From Kirkby Thore Parish Council ref 20032224

As noted in our previous representations to the various consultations on this project, Kirkby Thore Parish Council [KTPC] agrees that the A66 should be dual carriageway along its whole length. We accept that the route as it passes Kirkby Thore has been chosen as the Northern Route using the criteria stated by National Highways.

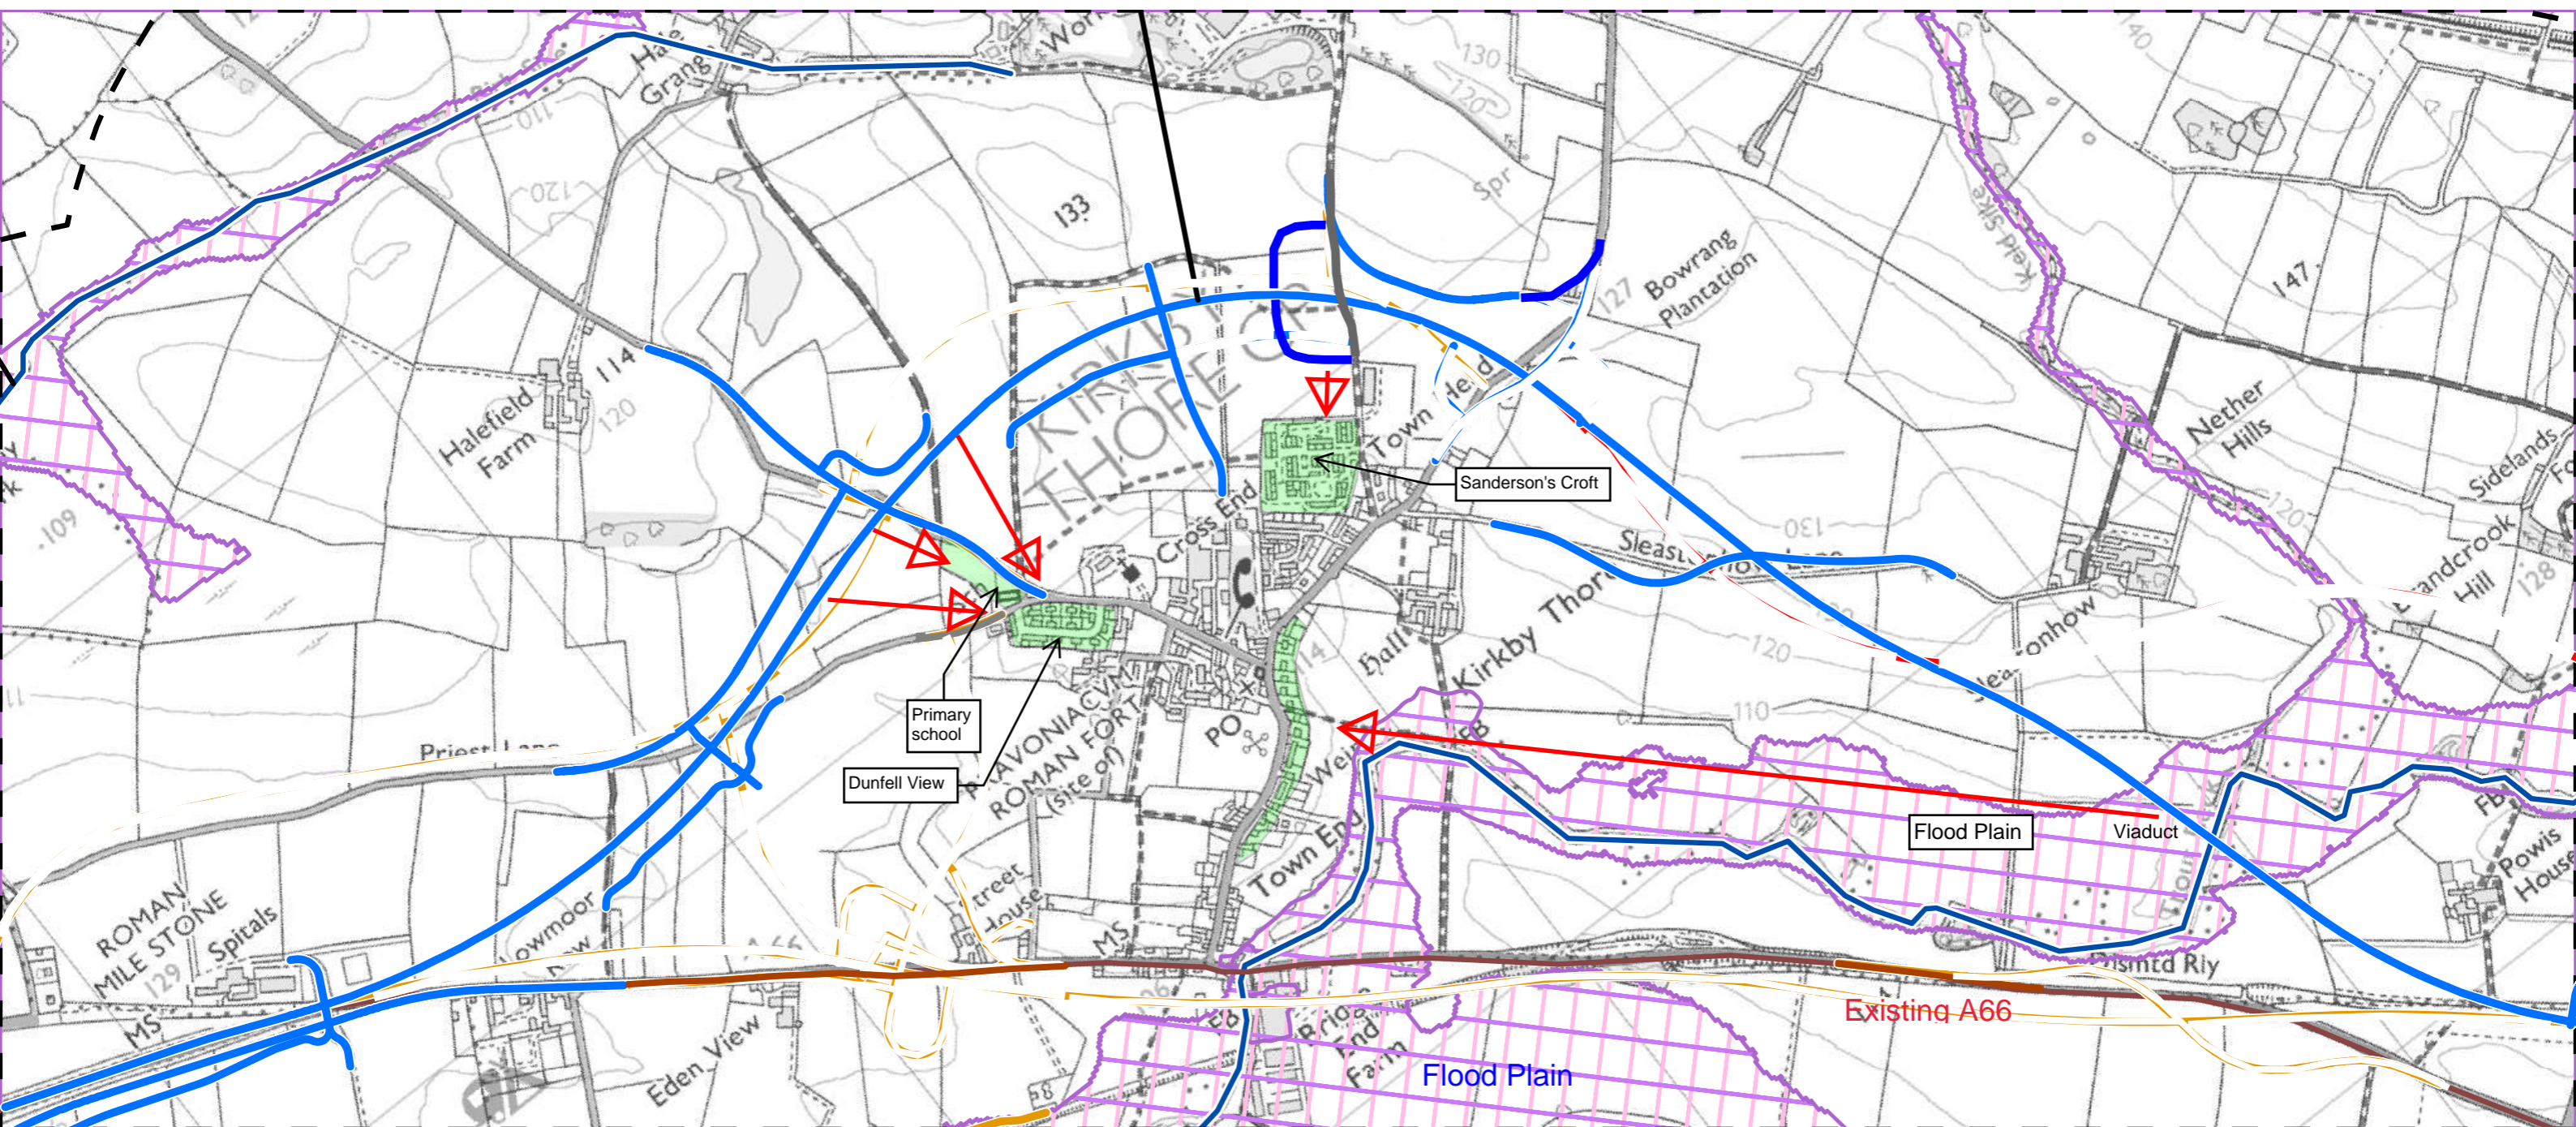
7) The environmental mitigation figures show two areas for lapwings, one of which is the area currently known as the Mire [noted on sheet 6] and is a wetland. Proposed retention of this area as a wetland is appreciated. However, we believe that both the areas shown may be too close to a busy road for lapwings to use. Has any consideration been given to additional areas further from the A66? Deer and hares also roam across this area to the north of the village and no specific consideration has been noted for them. Several buzzards use the area as hunting territory. The use of road verges for wildlife corridors is important when roads cut across territories thus fencing design is important to protect the vehicles from the larger wildlife while permitting movement. The Environmental Mitigation figures do not appear to show this level of detail but we note the importance of wildlife corridors and suitable fencing.

Map 1 - A66 Preferred Route around Kirkby Thore

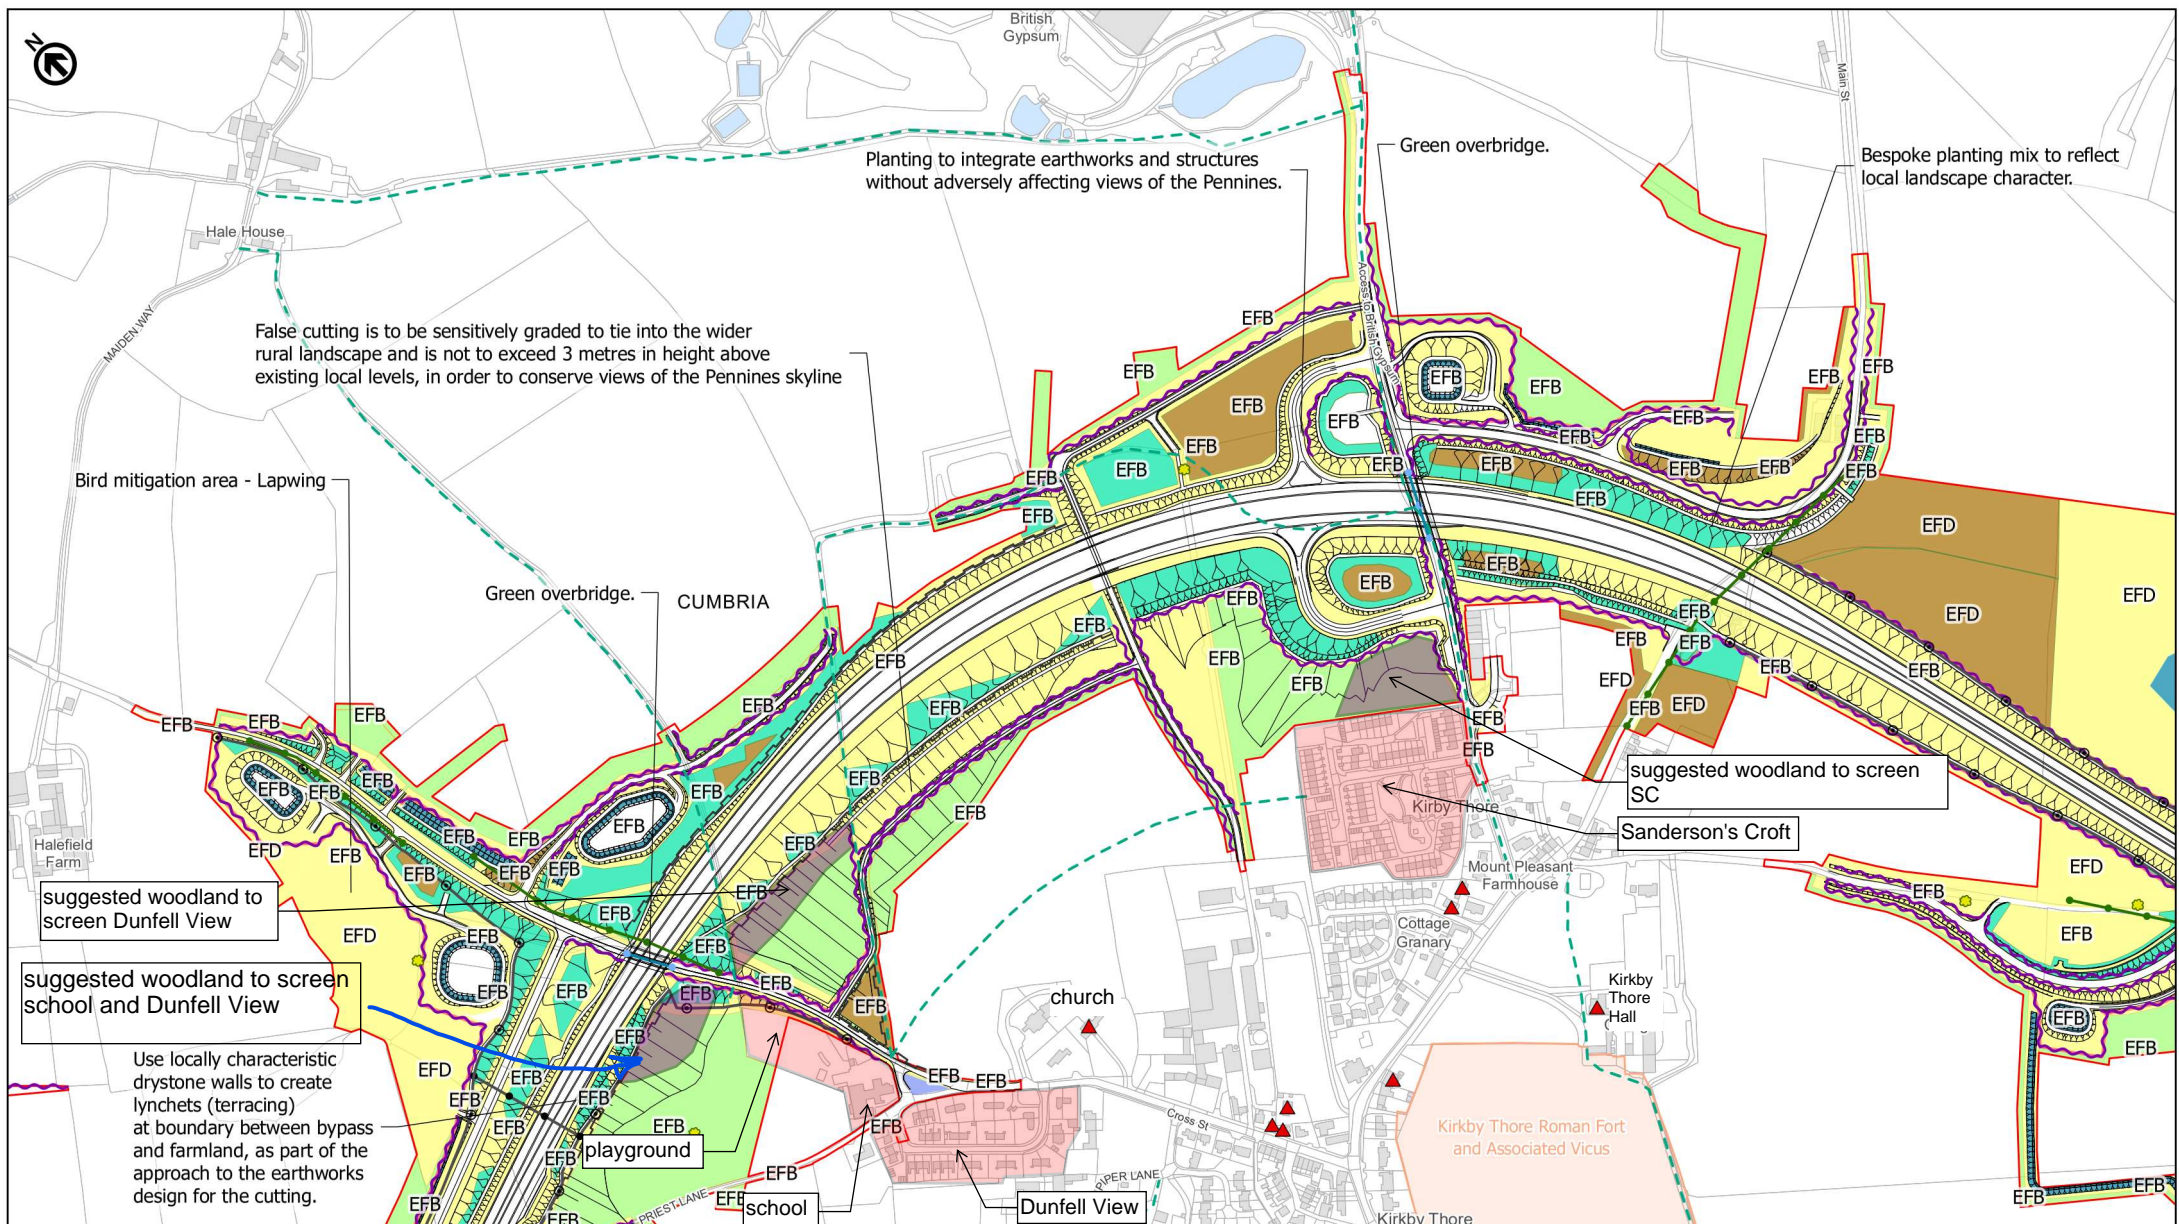
1) The A66 passes 180 degrees around Kirkby Thore in close proximity to the village, see Map 1, carrying traffic that is 27% Heavy Goods Vehicles [HGV]. This noise will be transmitted to the village from several directions. The significant receptors that are closest to the route are a) Sanderson's Croft, a housing association estate of 70 dwellings, and b) the primary school. Additional receptors are c) Dunfell View [35 dwellings] which is at a contour of 130m, while the passing road is cutting through the current ground level at the 120m contour, and thus not shielded by the road being in cut and d) the eastern side of Main St which looks eastward over the low ground of the Trout Beck flood plain to the proposed viaduct and is unshielded from noise or visual disturbance on that length of road.

5) Map 1 shows Kirkby Thore Main St adjacent to the Trout Beck flood plain and Environmental Mitigation Figure 2.8.5 sheet 6 shows the eastern side of the flood plain and the length of road and viaduct unshielded from the residents on Main St. The existing A66 transmits a noticeable amount of noise to the eastern side of the village and the 70mph limit dual carriageway would produce 3 times the noise of the 40mph A66, as the noise energy is proportional to the square of

9) As shown in Map 1 there is very little usable area between the proposed route and the village of Kirkby Thore. We understand that a works compound has been suggested for Kirkby Thore and, if this is the case, we suggest that any work area is sited the other side of the route from the village to minimise the effects on the village. This could possibly be adjacent to the existing eastern Temple Sowerby junction for the A66 or to the north of the road adjacent to the Gypsum Works; both of which have significant areas within the red line boundary.

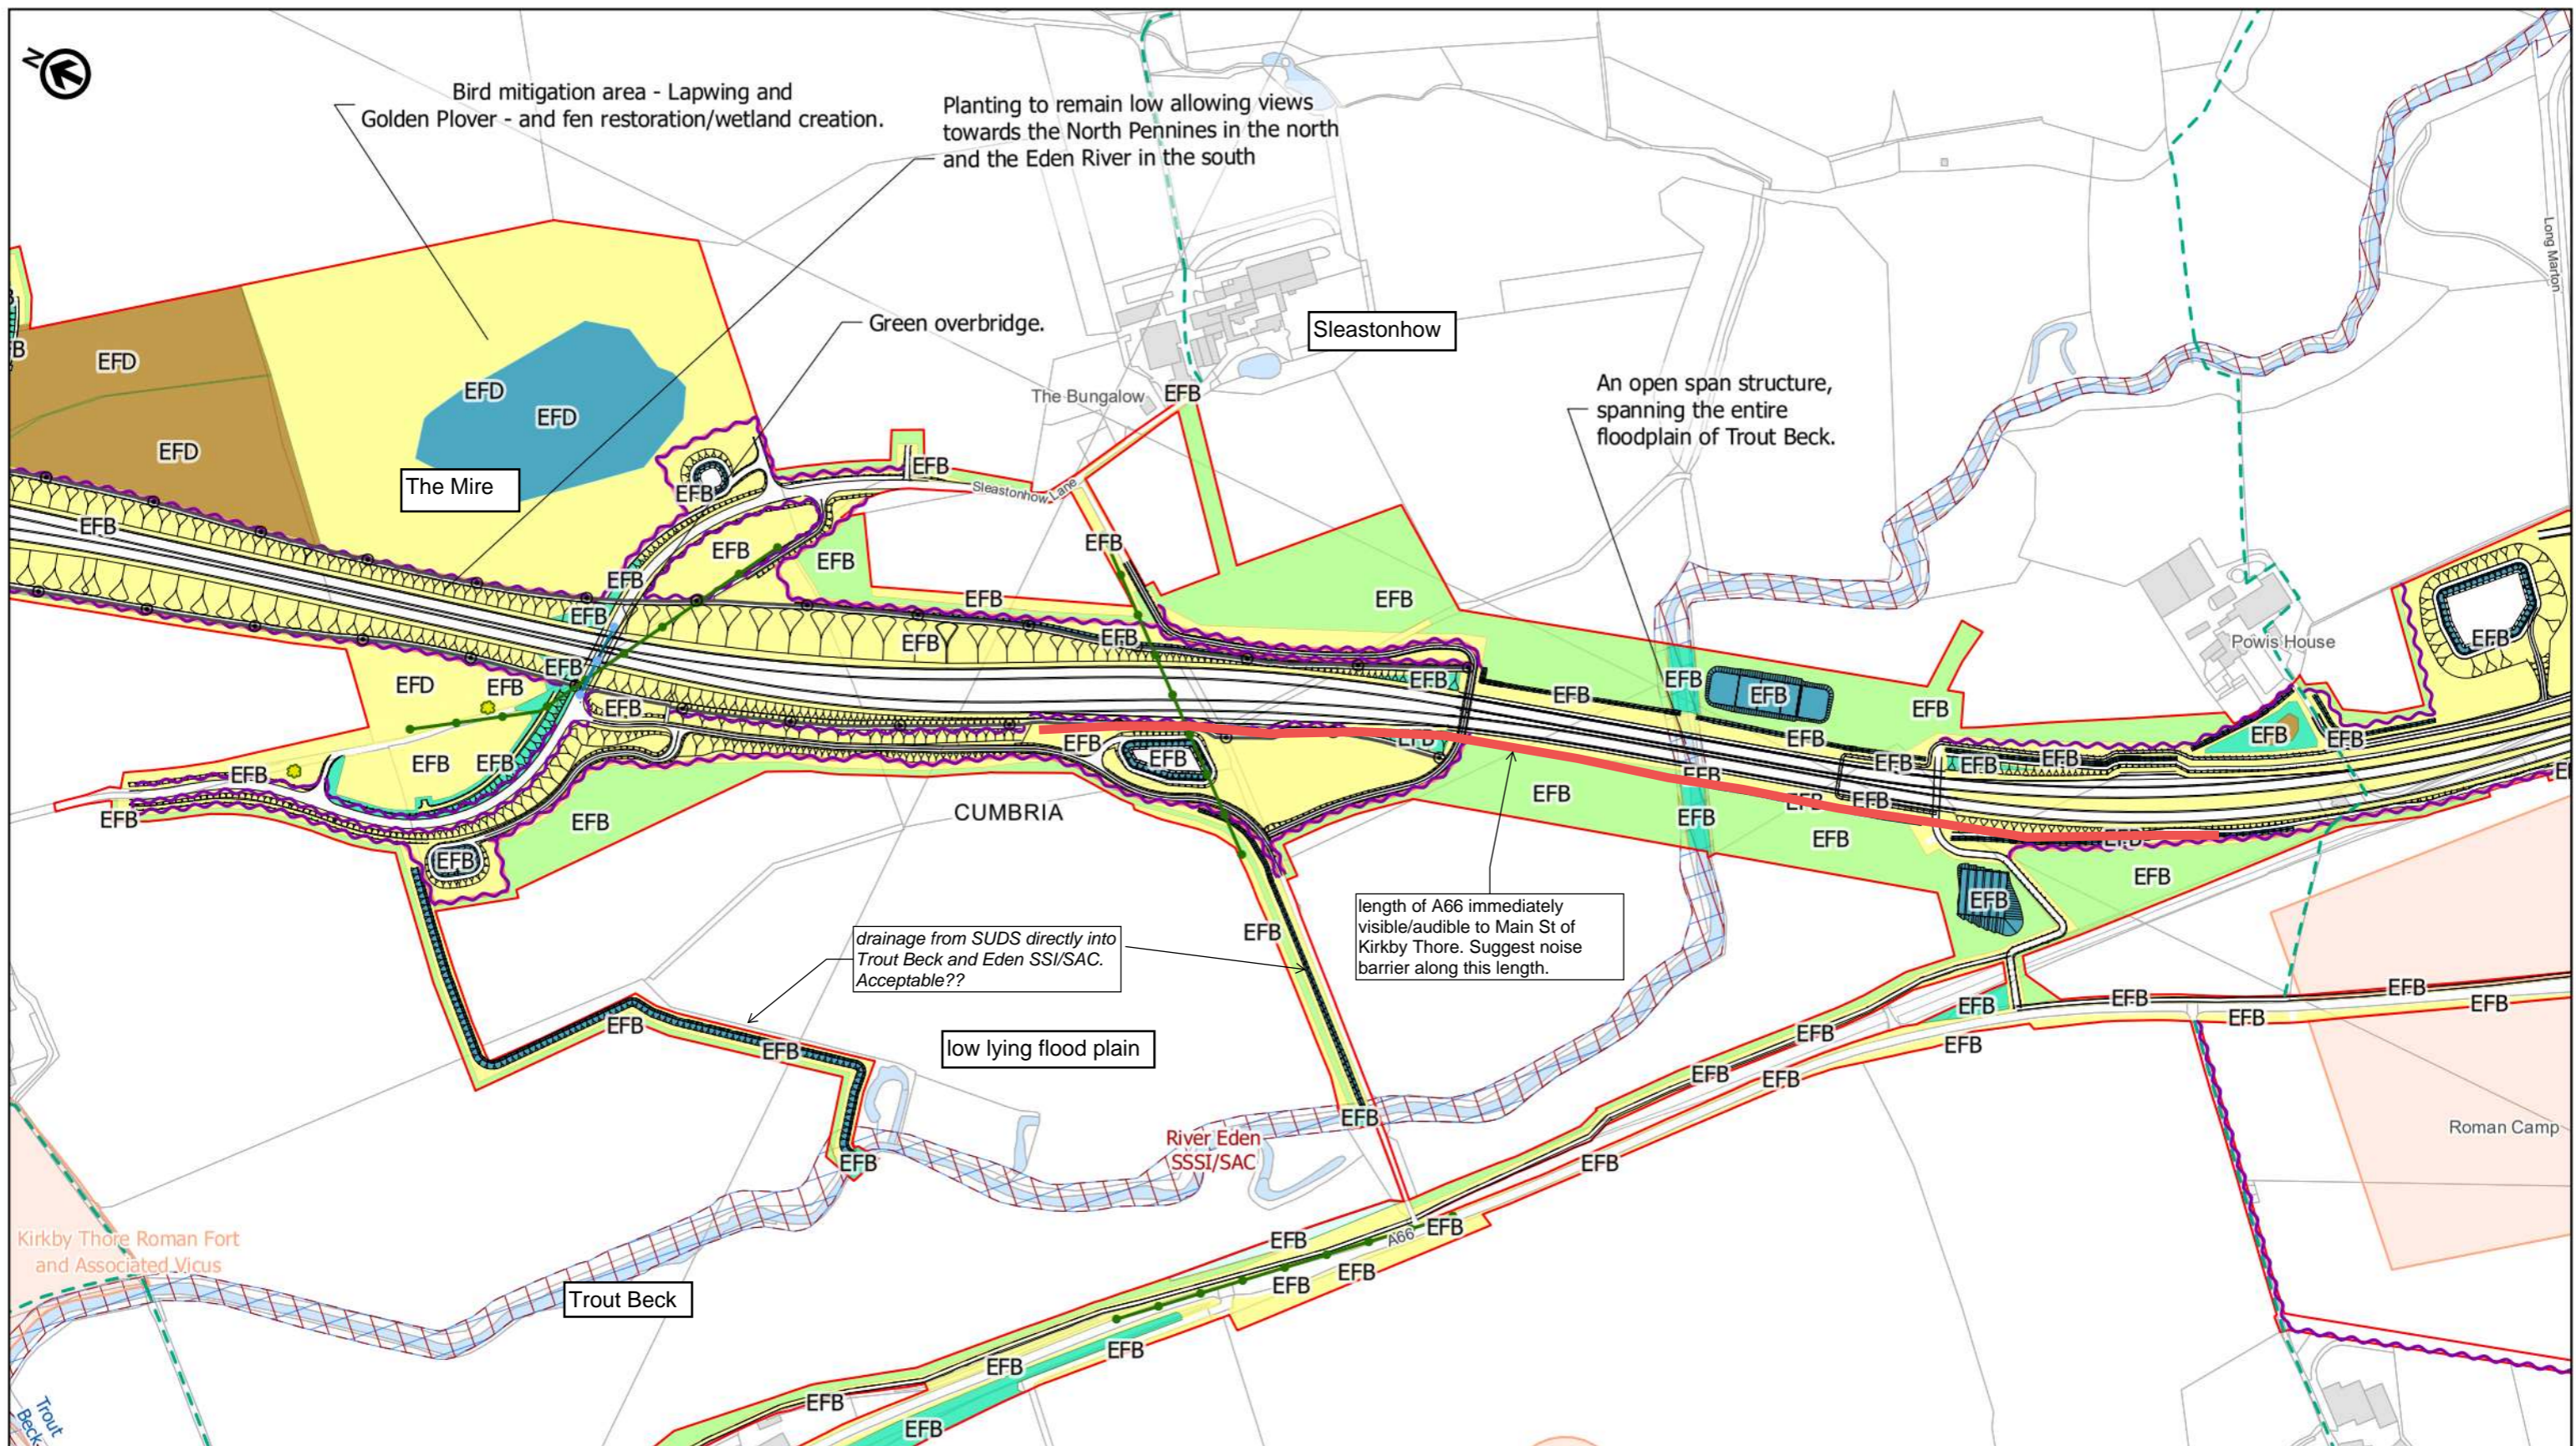
the speed. Acoustic fencing or baffles on the side of the Trout Beck viaduct could reduce the adverse effects on the residents. The proposed viaduct will also loom large in the landscape and impact on the villagers view to Appleby along the low lying plain. This is a loss to the residents that cannot be amended but highlights the importance of mitigating the nuisances of noise and headlight intrusion.

8) Figure 2.8.3 sheet 6 appears to show drainage ditches from the SuDS ponds directly into the Trout Beck, which is part of the Eden SAC. Can it be explained why this is acceptable.
